BULLETIN NUMBER:
CB20-N-001A

IMPORTANT SAFETY RECALL

HARNES INSPECTION AND CLIP INSTALLATION – 20V-195
(Transport Canada 2020-143)

- 2018-2020MY Isuzu FTR Vehicles Produced Between February 6, 2018 and February 5, 2020 (Canada Produced Between February 19, 2018 and December 4, 2019)

Figure 1

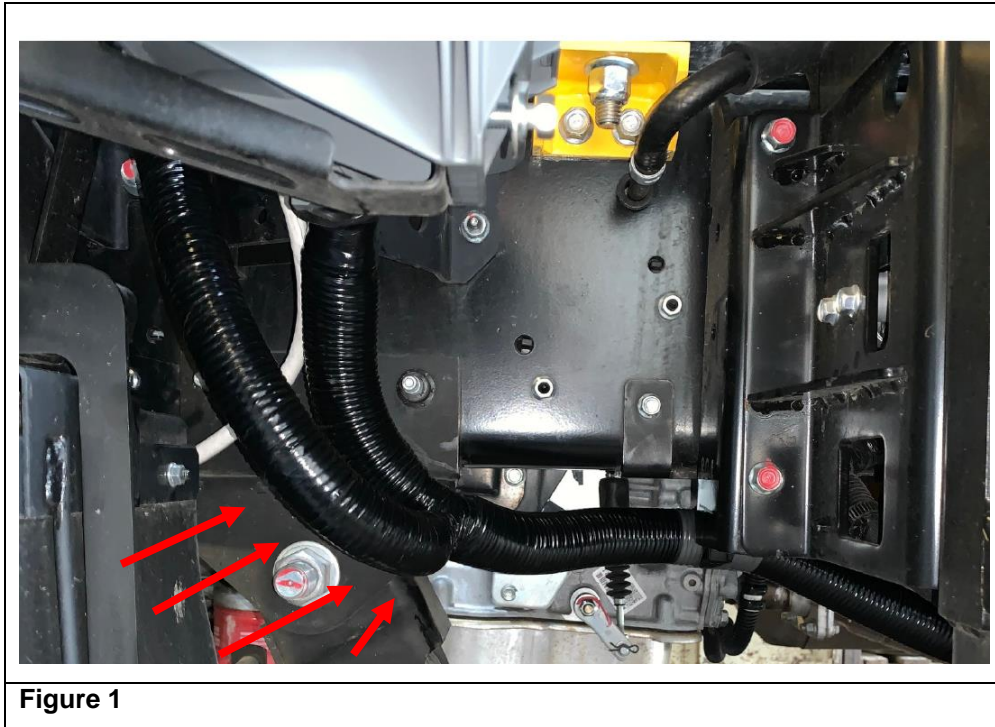
1. Place the vehicle in park, apply the parking brake, turn the engine off and block the rear tires.
2. Disconnect the negative (-) battery cable.
3. Inspect the Harness for contact with the Left Front Leaf Spring's, Rear Hanger Bracket.

- a. If there is any damage to the harness or wires, take a photo of the damage and email it to isuzuta@icta-us.com. Then call the Isuzu Technical Assistance Line at 1-877-478-9828, Prompt 3 for further instructions. Document the TAL case number on the repair order. This will be required for claim submission. After the harness has been repaired or replaced per the instructions from the Isuzu Technical Assistance Line, continue to Step 4.
 - b. If the harness is not contacting the spring hanger and/or there is no sign of harness damage continue to Step 4.
4. Familiarize yourself with the parts of the Harness Hardware Kit shown in Figure 2.

Figure 3

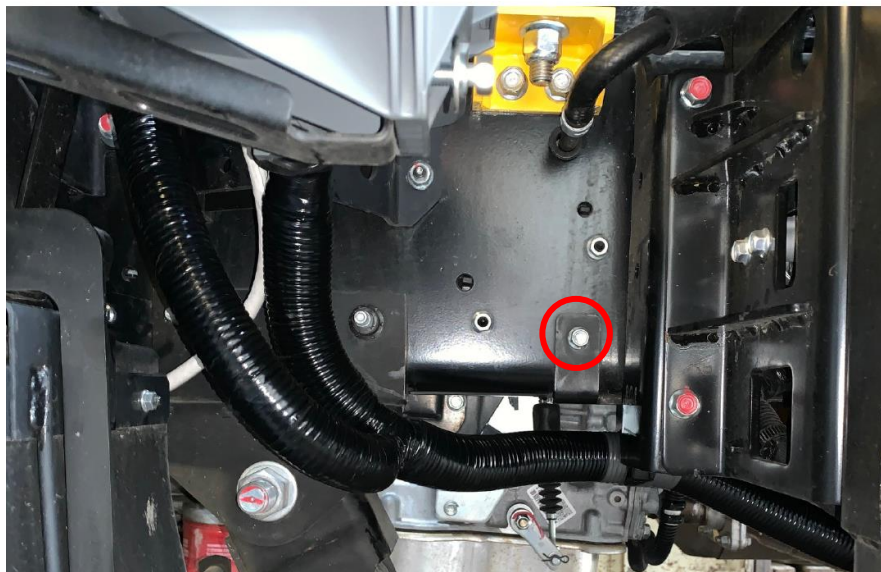
5. Remove the bolt and nut holding the forward tab of the wiring harness bracket as shown in Figure 3. Discard the bolt and nut just removed.

Figure 4

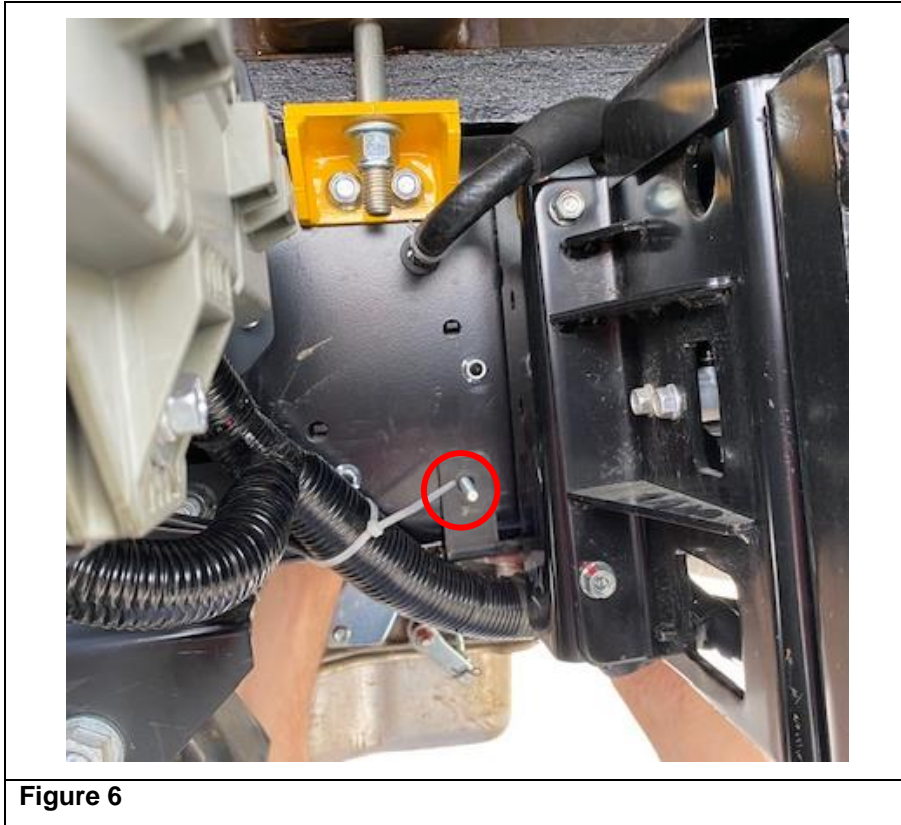
6. Insert one of the bolts from the kit through the hole in the fuse box bracket as shown in Figure 4. The threads of the bolt should be facing outwards from the bracket. Place the Upper Clamp over the harness approximately two (2) inches away from where the harness enters the fuse box. Firmly push upwards on the harness and slip the flat portion of the Clamp over the bolt. (See Figure 4.)

Figure 5

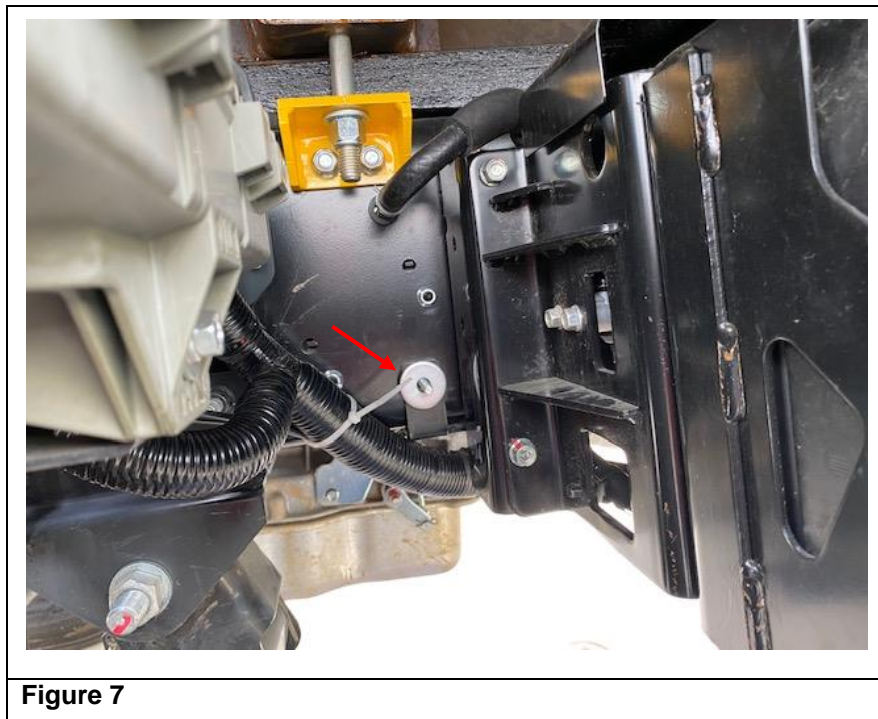
7. Firmly push or pull upwards on the harness while squeezing the Upper Clamp together in order to slip the outer hole of the clamp over the bolt. Turn a nut onto the bolt several turns by hand to hold clamp in place. (See Figure 5.)

Figure 9

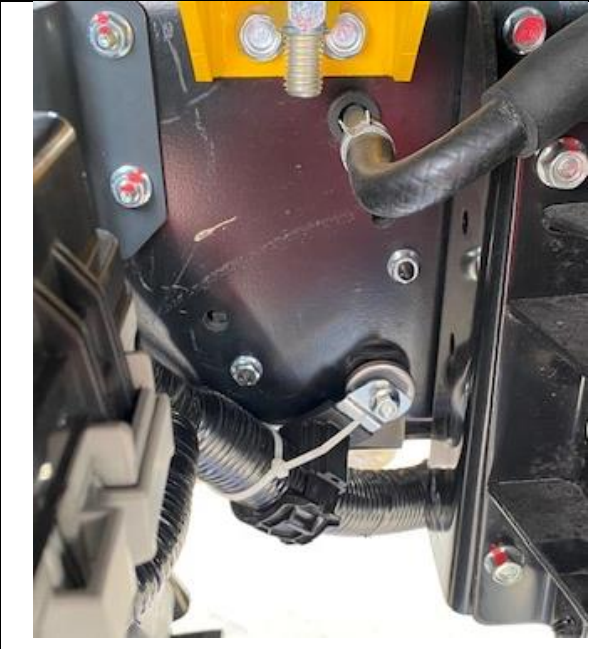
10. Place the Lower Clamp over the harness. (See Figure 8). Slip the Lower Clamp loop over the bolt, start a nut by hand several turns, and lightly snug the nut. (See Figure 9.) Lightly snap the ratcheting mechanism of the Lower Clamp onto the harness. (See Figure 9.)

Figure 10

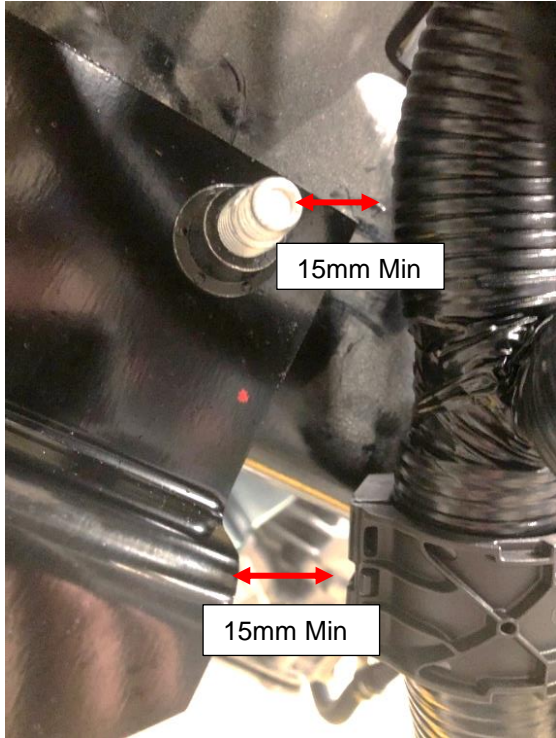
11. Adjust the Upper Clamp position until the harness has at least 15mm of clearance from the spring hanger bracket and bolt as shown in Figure 10. Position the Lower Clamp so that it is in line with the spring hanger bracket as shown in Figure 11. Hold the Lower Clamp in place when the clearance and Clamp position are correct and snug the nut down with a ratchet and socket.
